LAND USE BOARD APPLICATION

**Re: Completeness Review No. 1
Minor Site Plan w/ Use Variance
Applicant: Mark Landgrebe
Block 58, Lot 7.01
44 Miller Street
Borough of Highlands, Monmouth County, New Jersey
REG File No.: HLPB25-10**

MINOR SITE PLAN
W/ 'D' VARIANCE
44 MILLER STREET
LOT 7.01 BLOCK 58
BOROUGH OF HIGHLANDS
COUNTY OF MONMOUTH NEW JERSEY

JAMES T. DALEY
ARCHITECT
+ ASSOCIATES
273 FIRST STREET, KEYPORT, NJ 07735
phone: 732-739-2684 fax: 732-739-0837

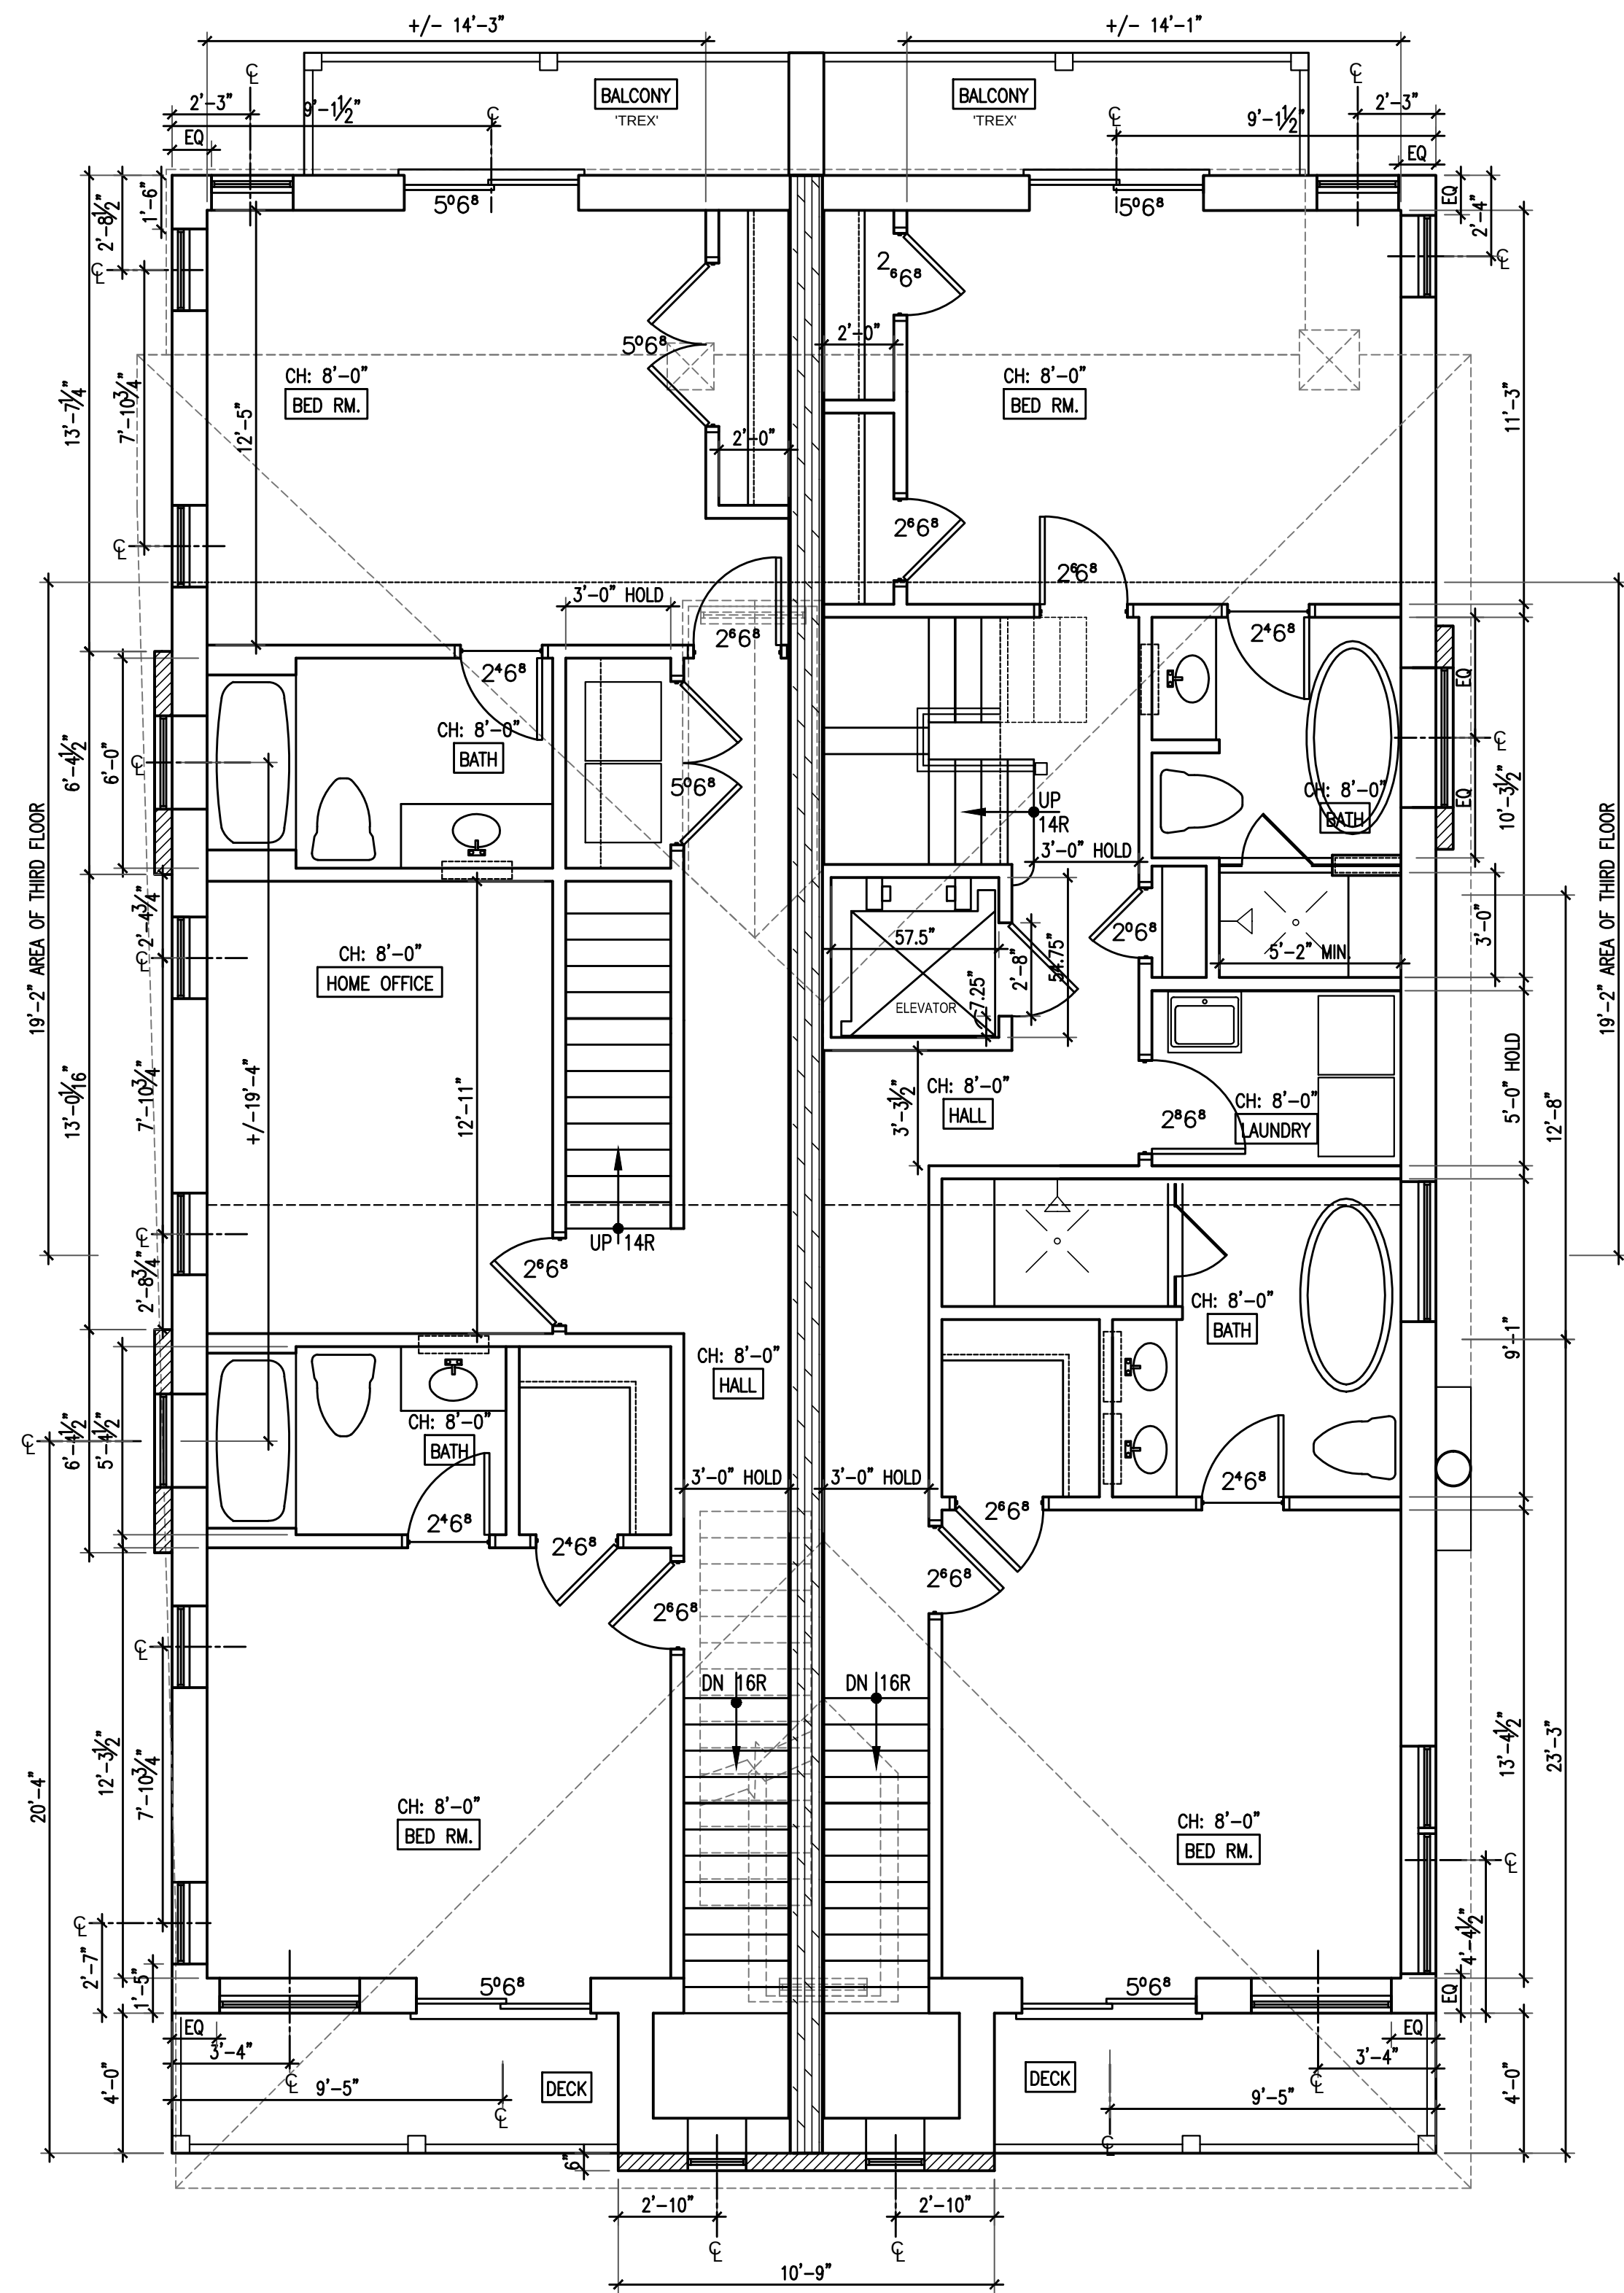
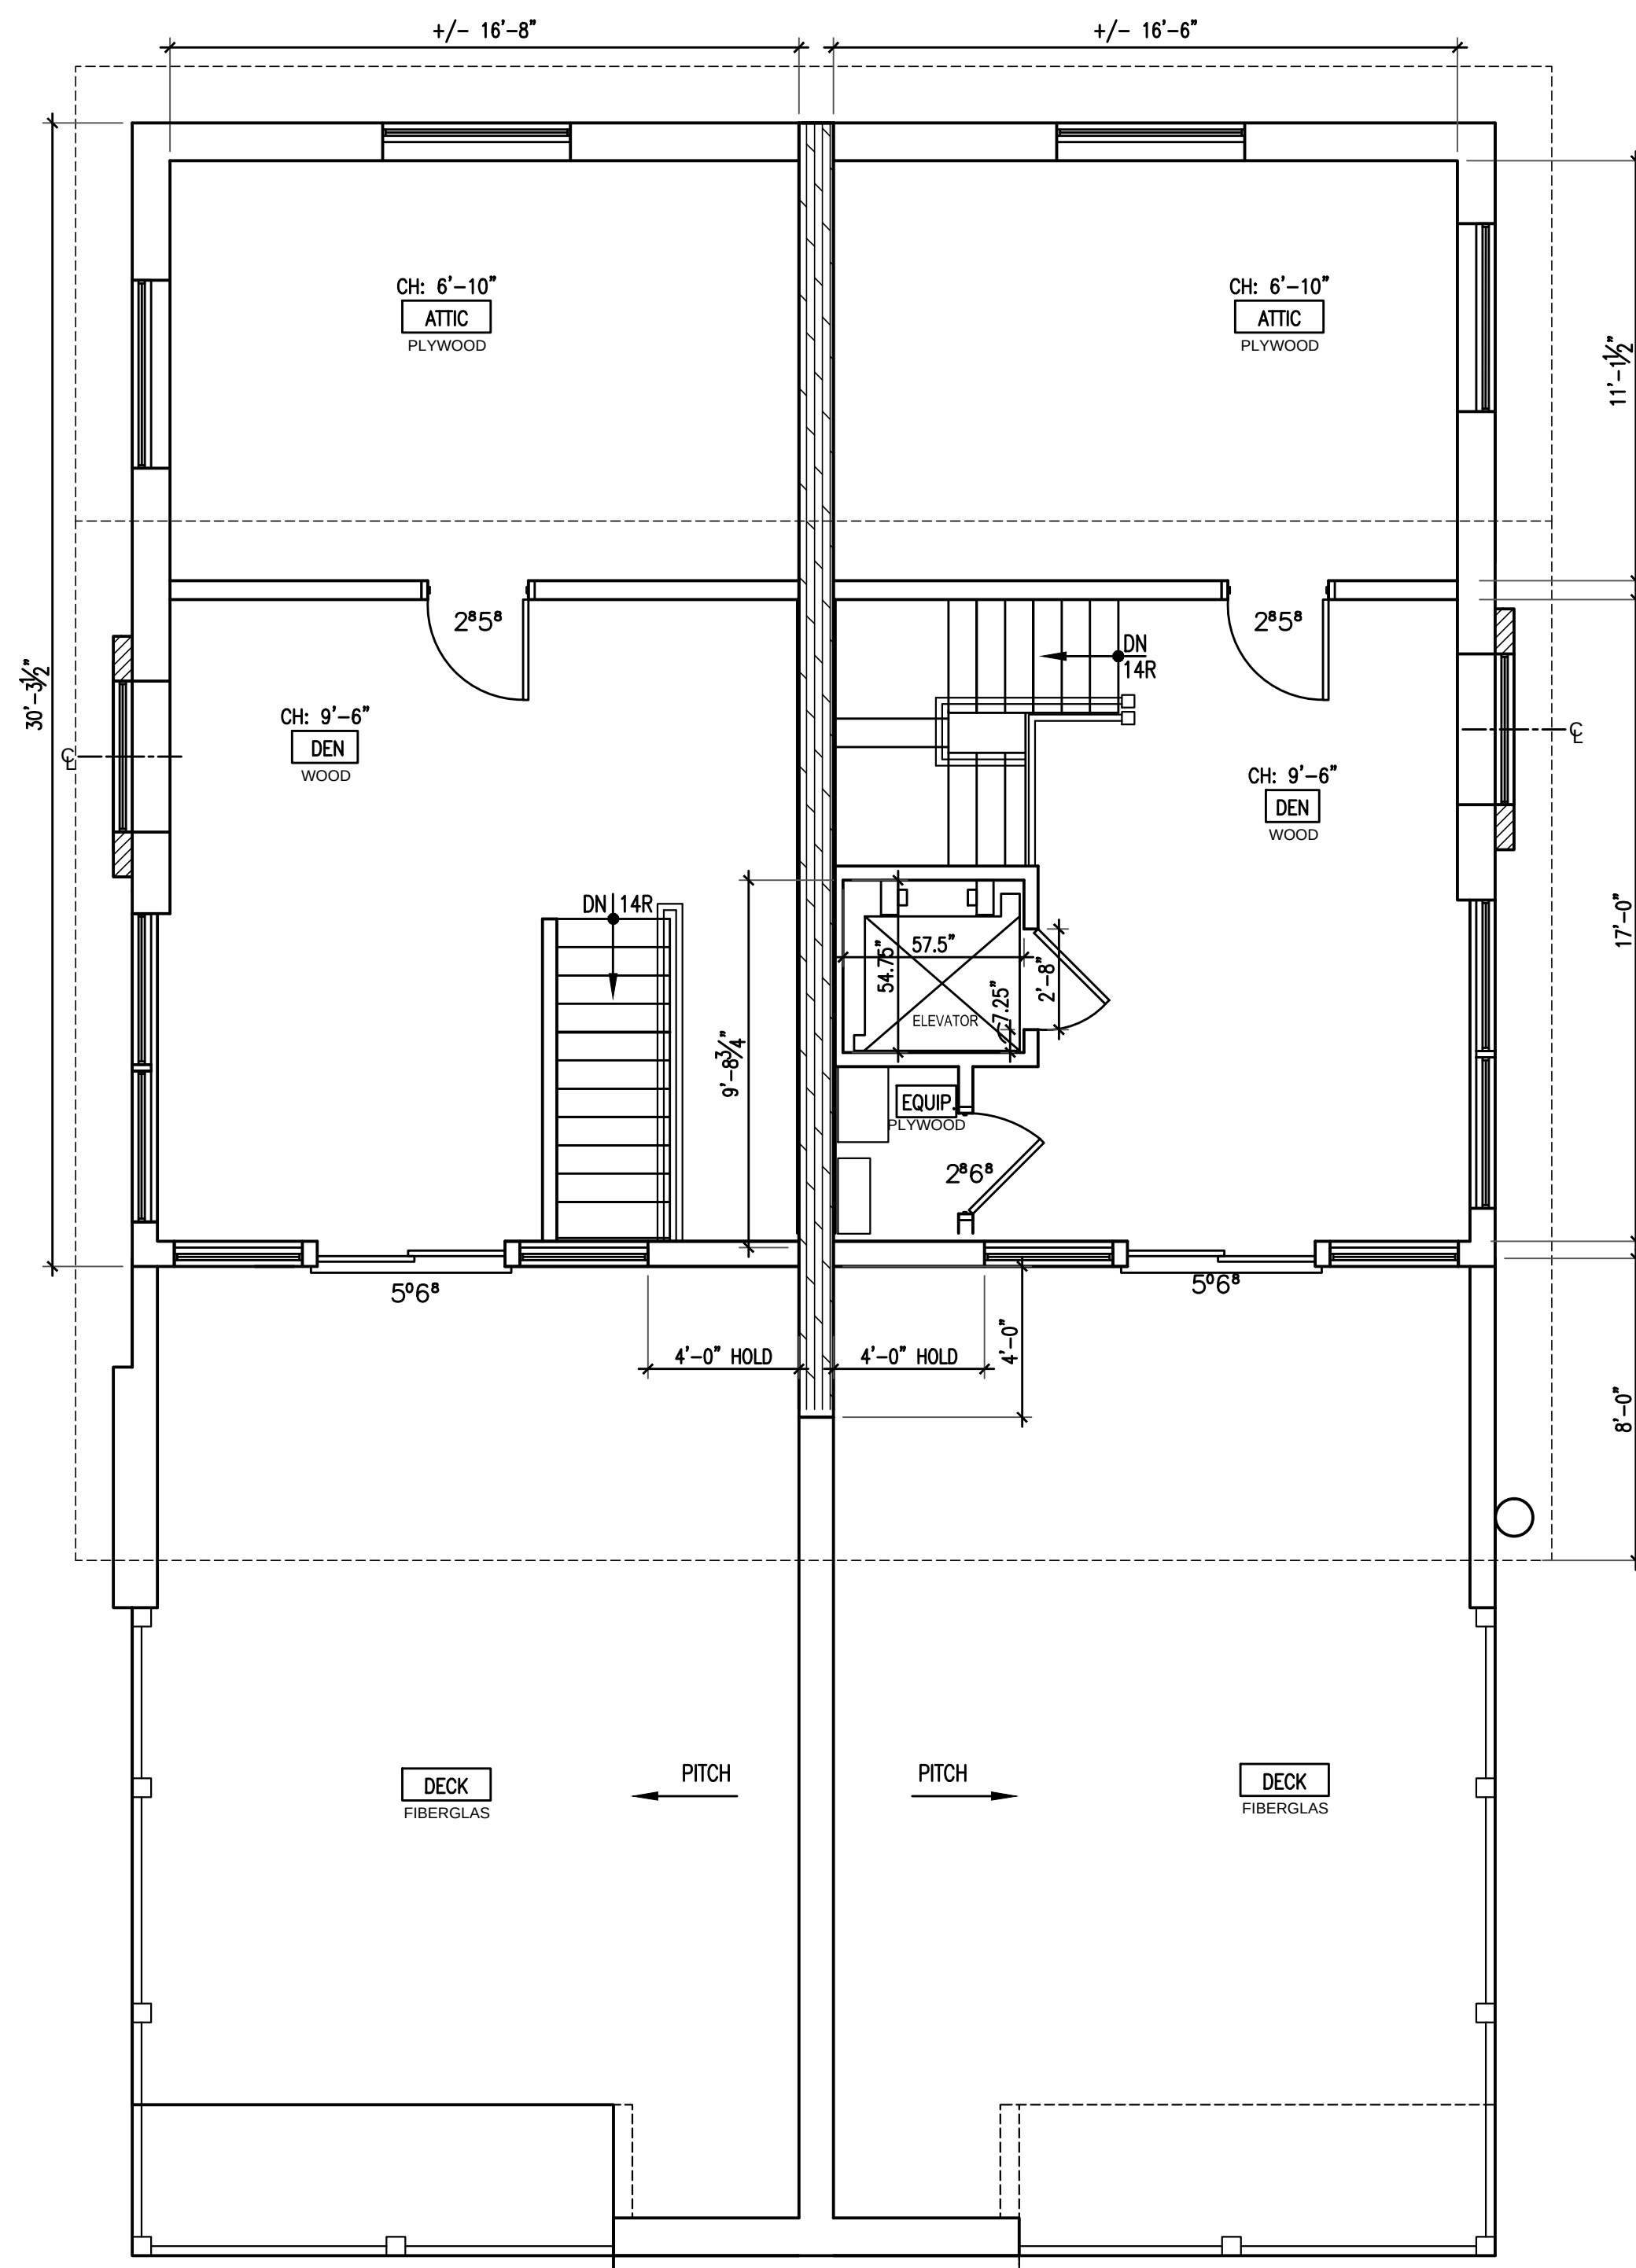
5. Please provide signed and sealed Architectural plans.
6. Please update the zoning information on the Architectural plans to be consistent with the Site Plan.
7. Please update the building height as 32'-0" and add elevations to a side section on the Architectural plans.
8. Please update the parking requirement table according to §21-65.14.C.1 Off-street parking.

Response: To be provided under separate cover.

Response: Updated Architectural plans to be provided under separate cover.

Response: Updated Architectural plans to be provided under separate cover.
